Subject: DA2022/0469 - 1102 Barrenjoey Road, Palm Beach (Our Ref:21-131A)

Re: DA2022/0469 – AMENDED PLANS ("the Amended DA"); Construction of shop top housing ("the proposal"); 1102 Barrenjoey Road, Palm Beach ("the development site").

Re: DA2022/0469 ("the DA");

Construction of shop top housing ("the proposal"); 1102 Barrenjoey Road, Palm Beach ("the development site").

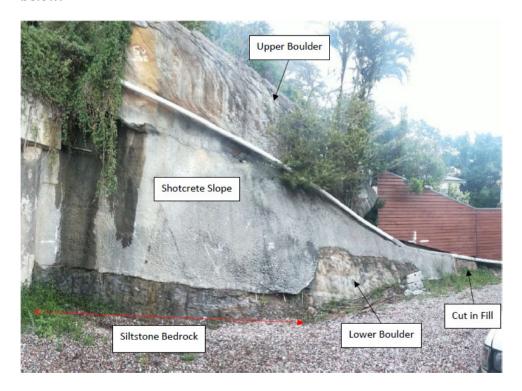
The proposed building height is excessive. The redevelopment already approved on the development site (which the Applicant says has been physically commenced as a result of geotechnical investigations having been carried out) exceeds the 8.5m height limit in PLEP 2014 by 1.655m or 19.4%. The new proposal exceeds the 8.5m height limit by approximately 3.0m or 35%.

In addition to being non-compliant with the building height limited in PLEP 2014, the proposal is out of character with the surrounding area, and is incongruous in height, scale and bulk when compared to our client's property (and to Barrenjoey House).
